Re: **Kittery Aroma Joes | Site Plan Peer Review Comments**

Haley Ward, Inc. (Haley Ward) has prepared the following response to the review comments on the 523 US Route 1 Aroma Joes development, provided by Jodie Strickland (CMA Engineers) on November 8, 2021, and by the TRC on November 29, 2021. The comments have been provided in bold italics, followed by our response.

**RE: Town of Kittery, Planning Board Services
523 US Route 1, Aroma Joe's Site Plan Review Application
Tax Map 66, Lot 26; Mixed Use (MU) Zone
CMA #591.139**

PROPOSED SITE PLAN

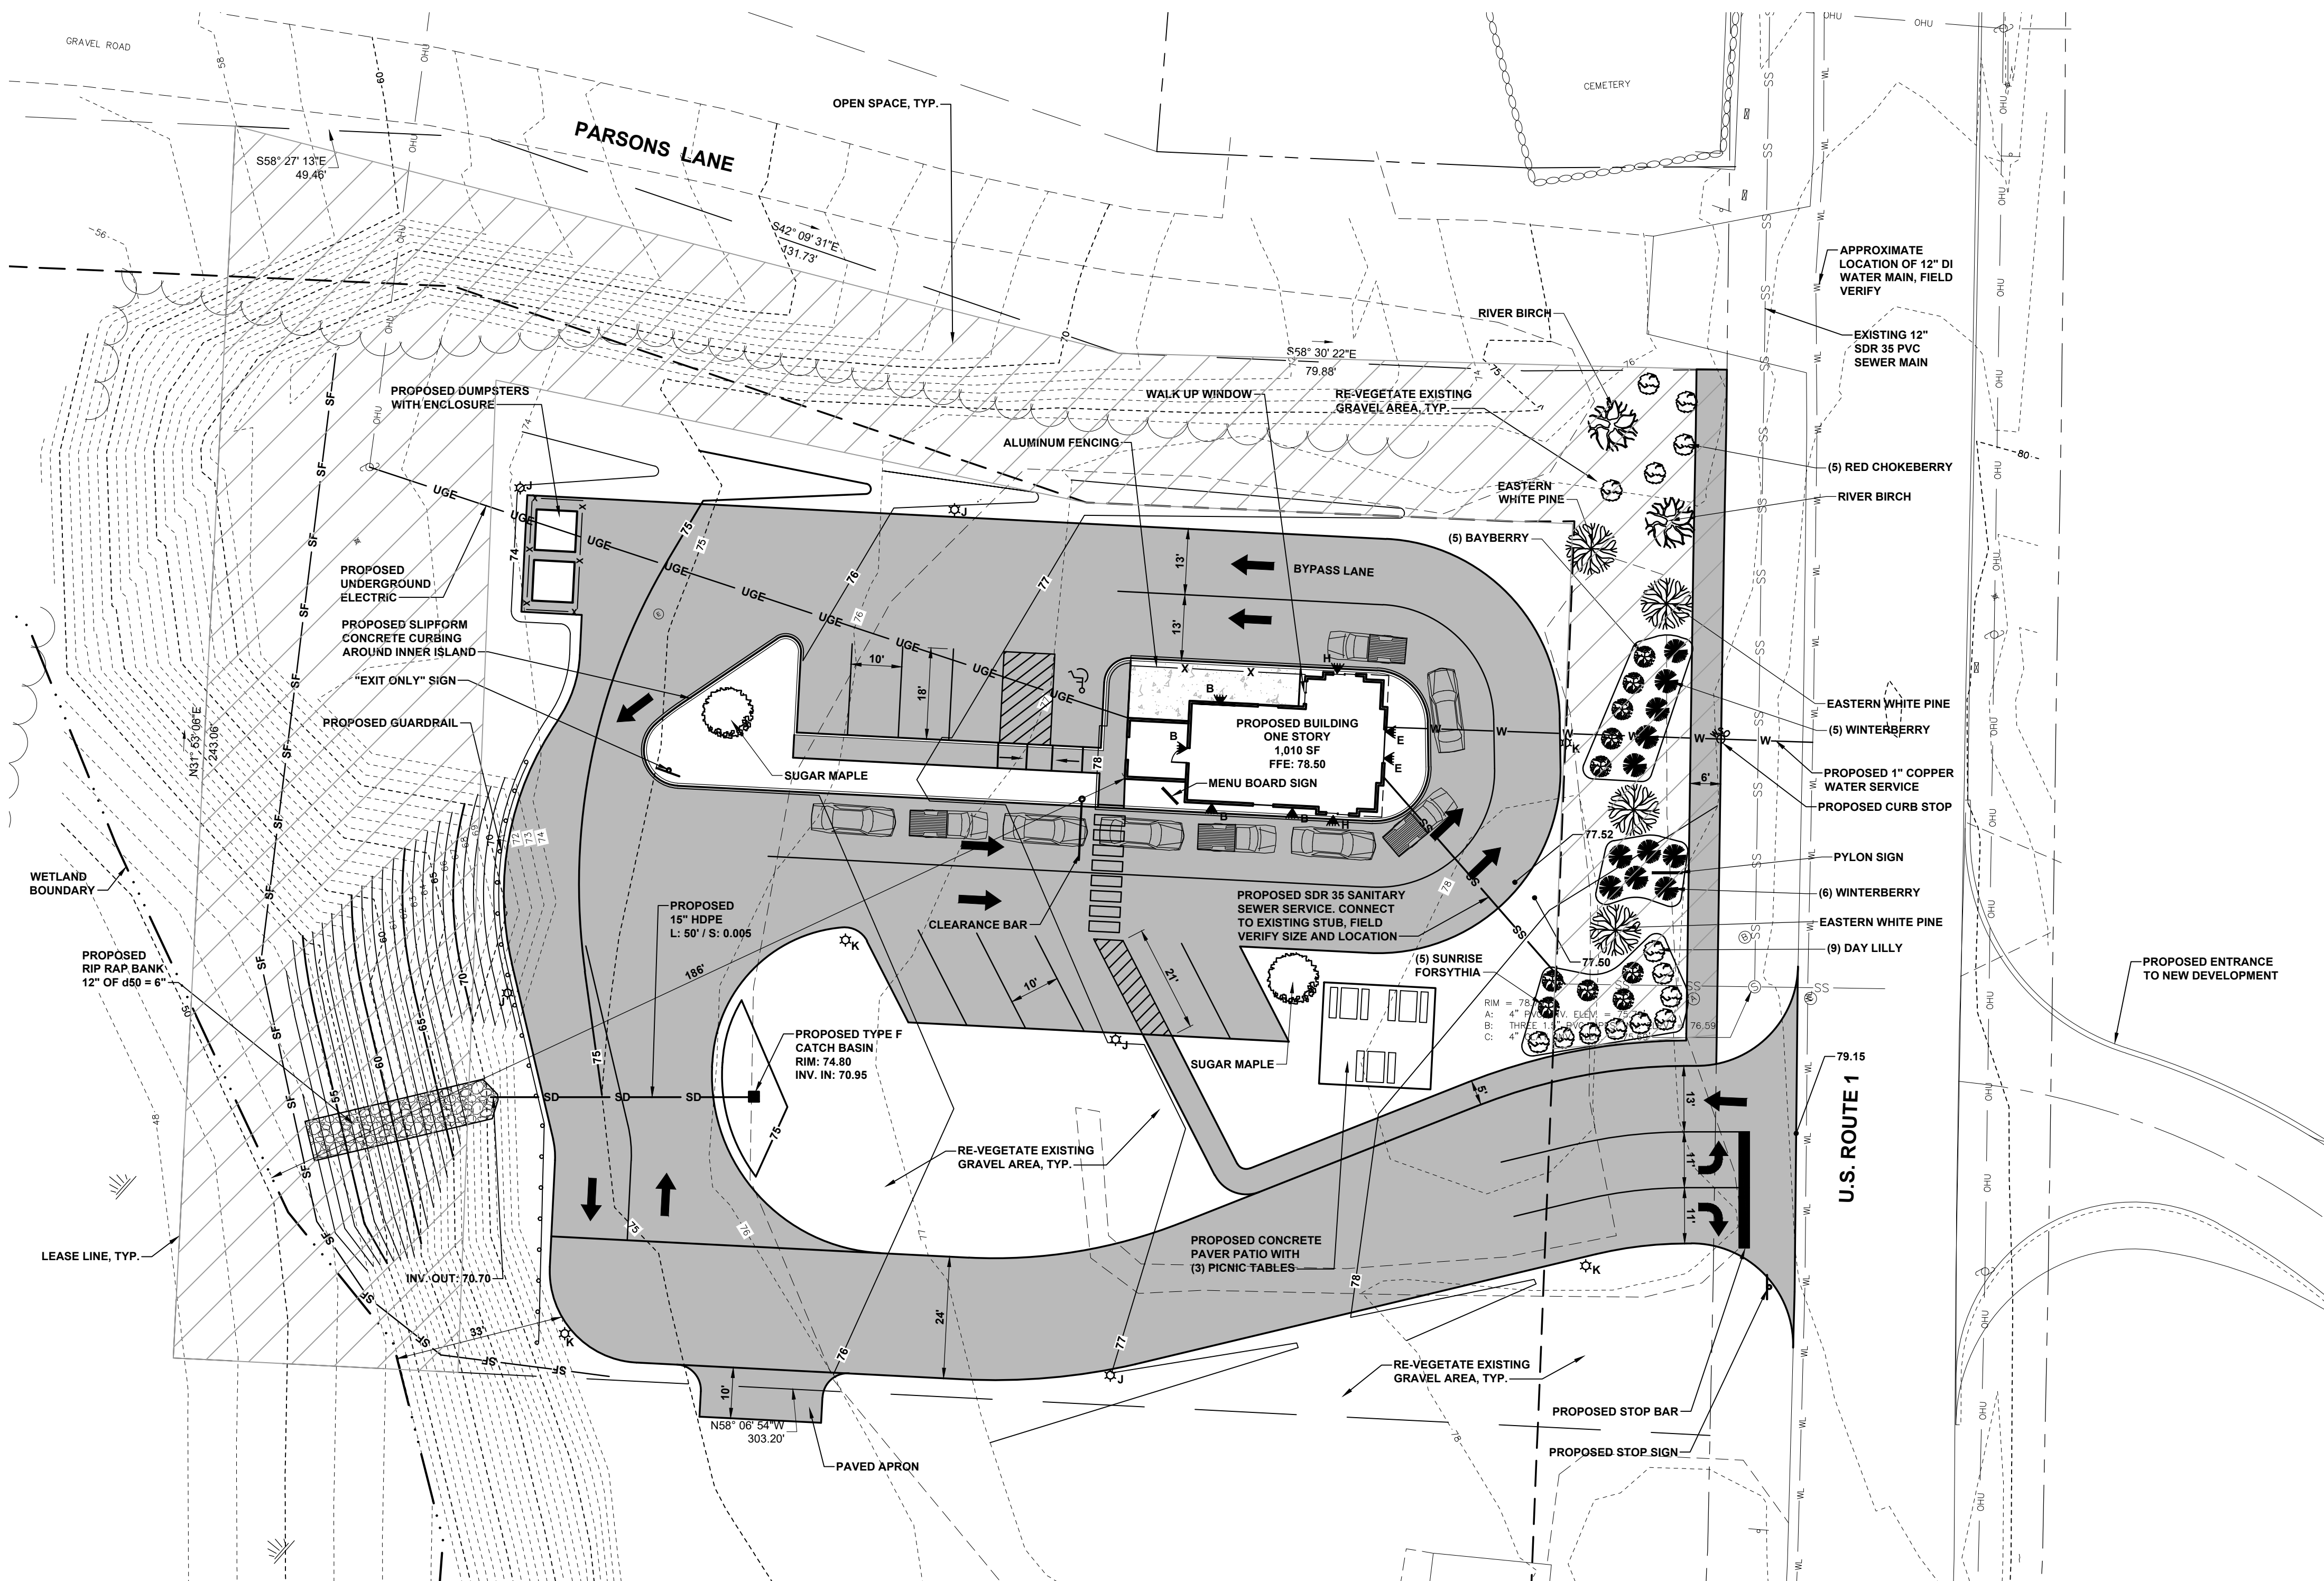
- 2. The project proposes to use Kittery Water District water. The applicant should indicate the size and material of the service. The applicant should indicate the location of the proposed curb stop. Where is the closest existing hydrant located? The plans should show the size and material of the existing water main. The plans should provide details for the water service (size, material, bedding, curb stop, etc.) Is fire suppression required?***

- 3. The applicant proposes to use Kittery sewer. The applicant should indicate the size and material of the service. The applicant should indicate the location of the proposed cleanout. The plans should show the size and material of the existing sewer main. The plans should provide details for the sewer service (size, material, bedding, cleanout, etc.) Is a grease trap required for this service? The proposed sewer service should be reviewed and approved by the Superintendent of Sewer Services.**

- 10. 16.9.3.1. The plan identifies wetlands. Site development and disturbance appears to avoid the setbacks associated with the wetlands, however, the proper setback should be indicated on the plan.**

The TRC recommends that sidewalks be placed along the frontage of Route 1 outside of the right-of-way within the property, considering there is limited space within the right-of-way. The TRC also agreed this requirement may occur only within the leased portion of the property, with a condition that any development that were to occur on any portion of the remaining vacant land would need to be improved.

The Proposed Site Plan and Detail Sheet have been updated with the requested information. The closest hydrant is approximately 250' north at the York Colonial Center. The Town does not require the building have a fire suppression system.

The Proposed Site Plan and Detail Sheet have been updated with the requested information. The Town does not require a sewer service cleanout. There will be no cooking at this facility, all food is pre-prepared and re-heated in an oven; no grease trap is required. Correspondence with the Superintendent of Sewer Services was provided with the original application, and the service was designed using their provided guidelines.

Applicable wetland setbacks for this development include roadways (30'), parking areas (100'), and buildings (100'.) These setbacks have been added to the Proposed Site Plan.

A sidewalk has been added along the R.O.W. line, as shown on the revised Proposed Site Plan.
